CITY OF ALBUQUERQUE

**Re: Far North Shopping Center, 4600 San Mateo Blvd. NE,
(E-18/D019B)**

Re: Far North Shopping Center Parking Addition (Tract S-1)
Grading and Drainage Plan
Engineer's Stamp dated 02-23-09 (E-18/D019B)

DRAINAGE REPORT
FOR

EXISTING CONCRETE RUNDOWN DRAINAGE CAPACITY

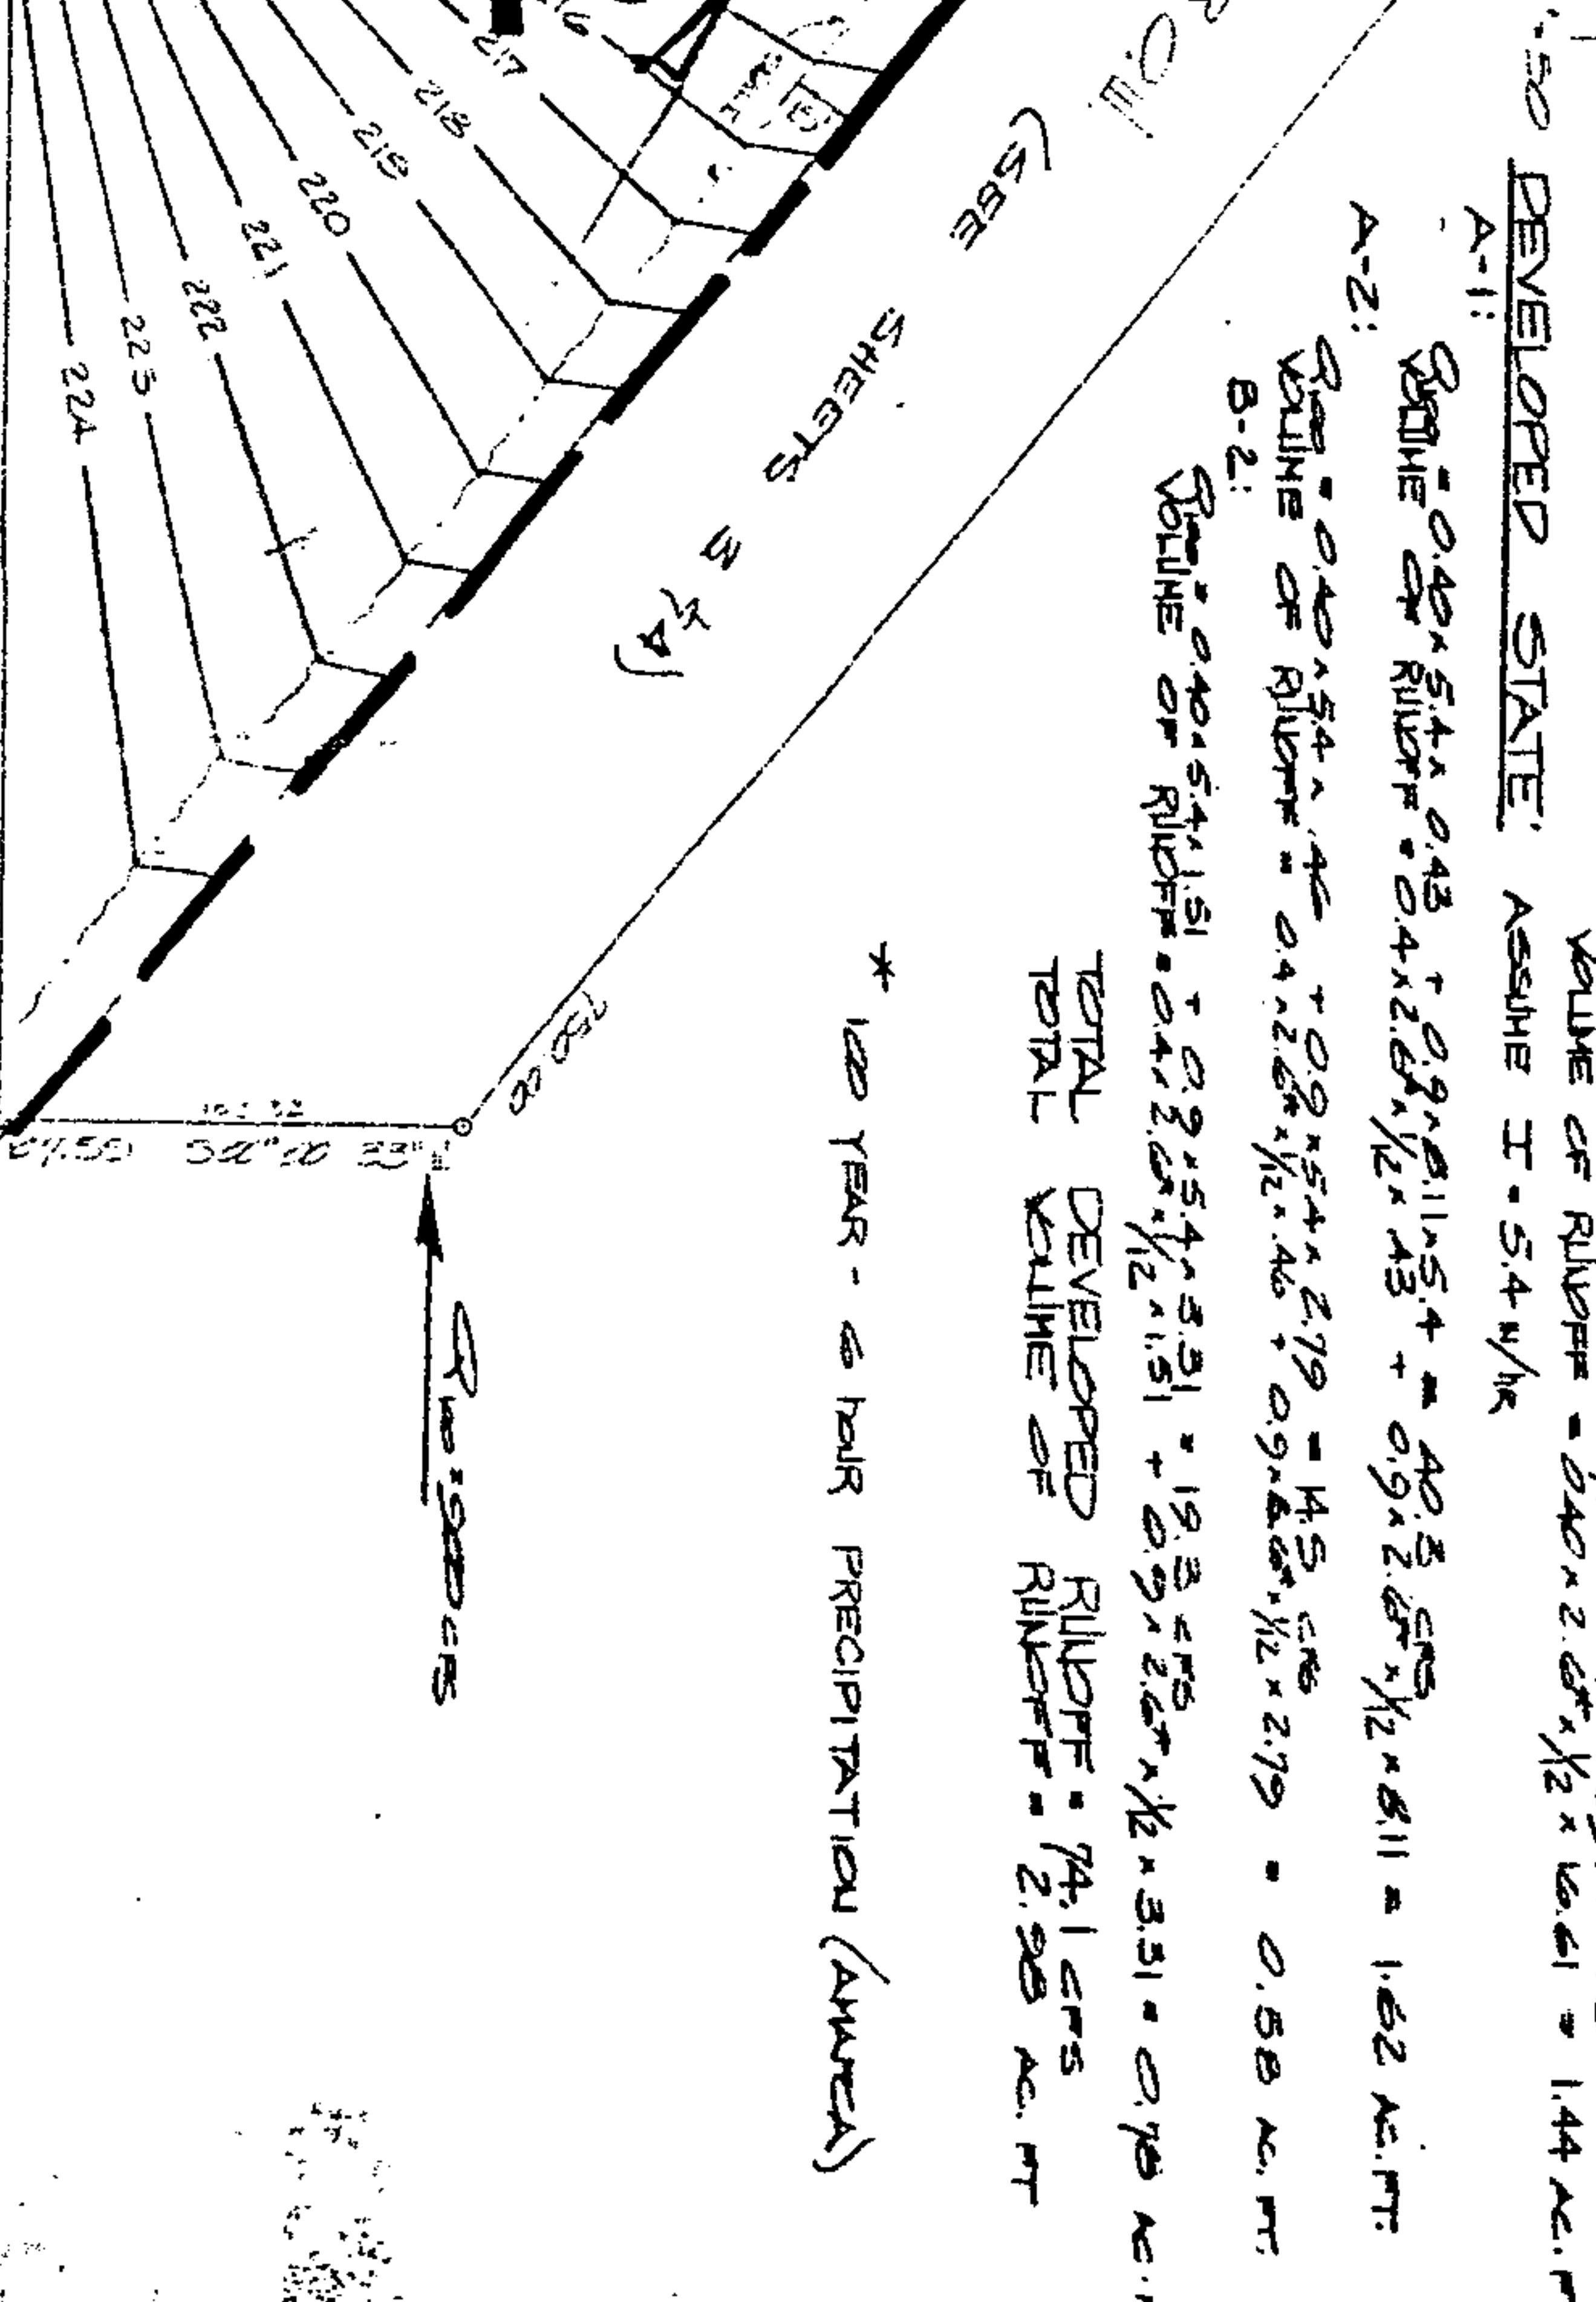
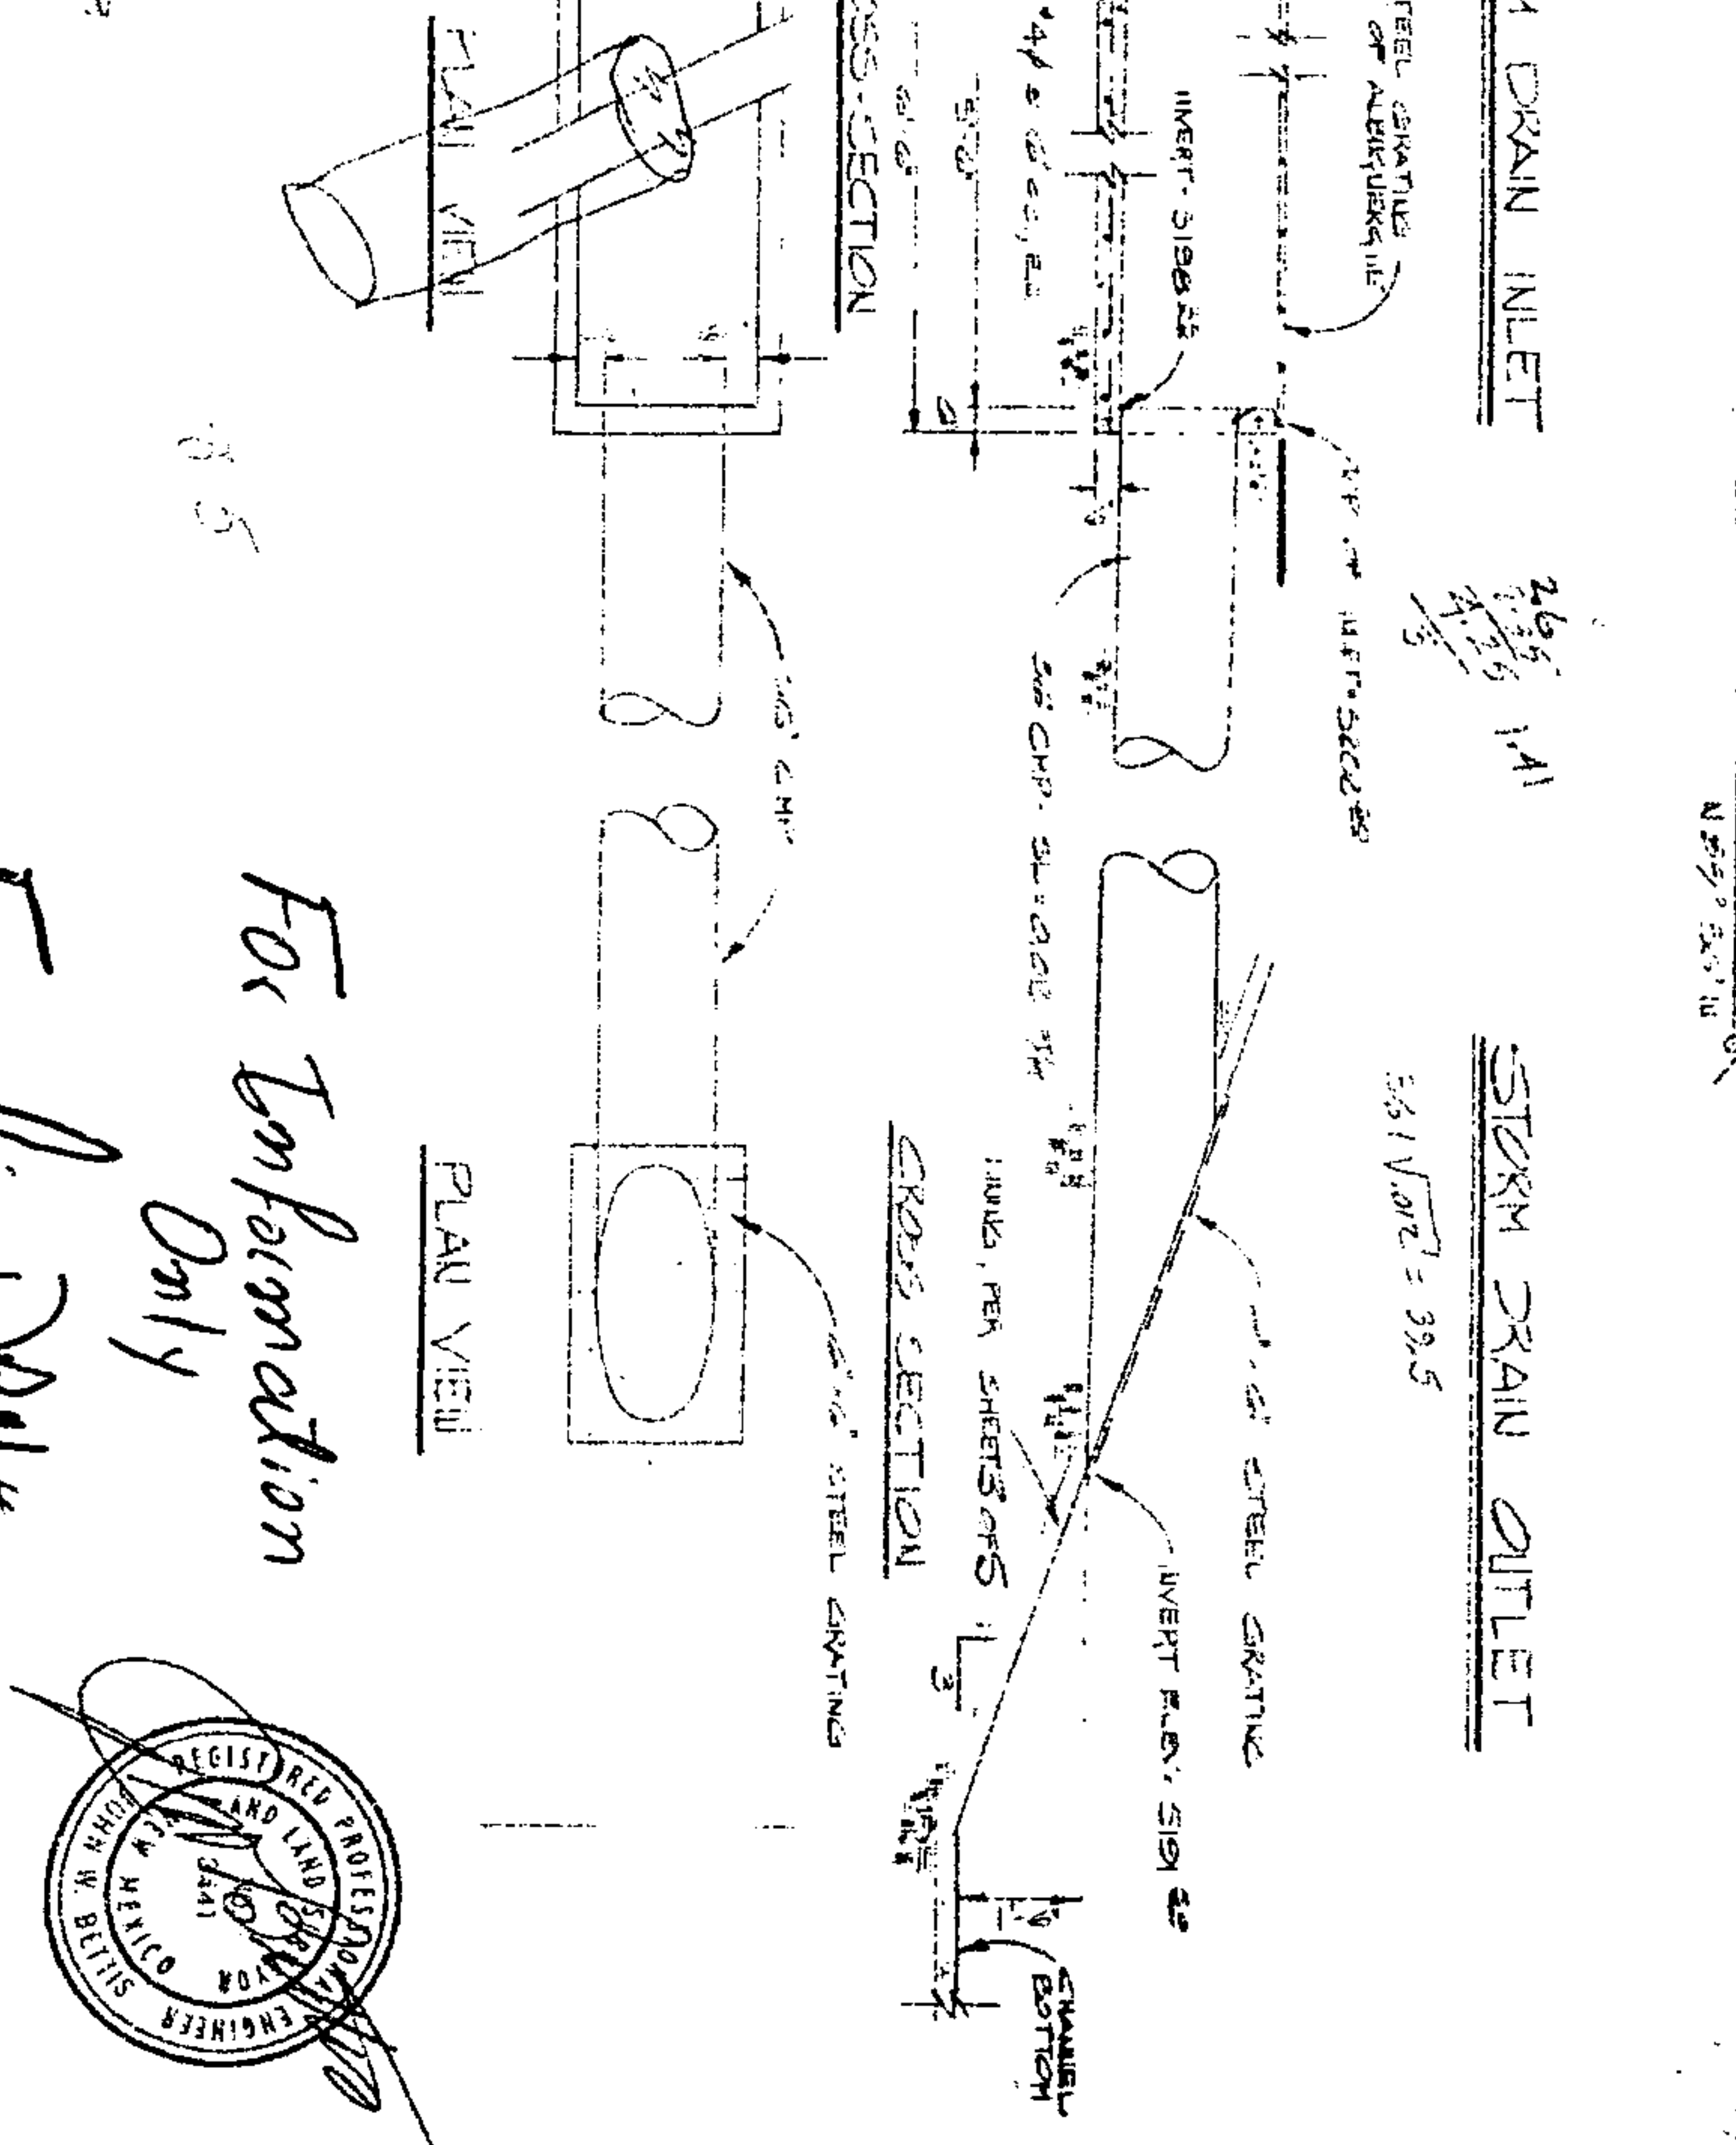
*Where are they
located on
Grading & Drainage
Plan ??
Need to
Identify!*
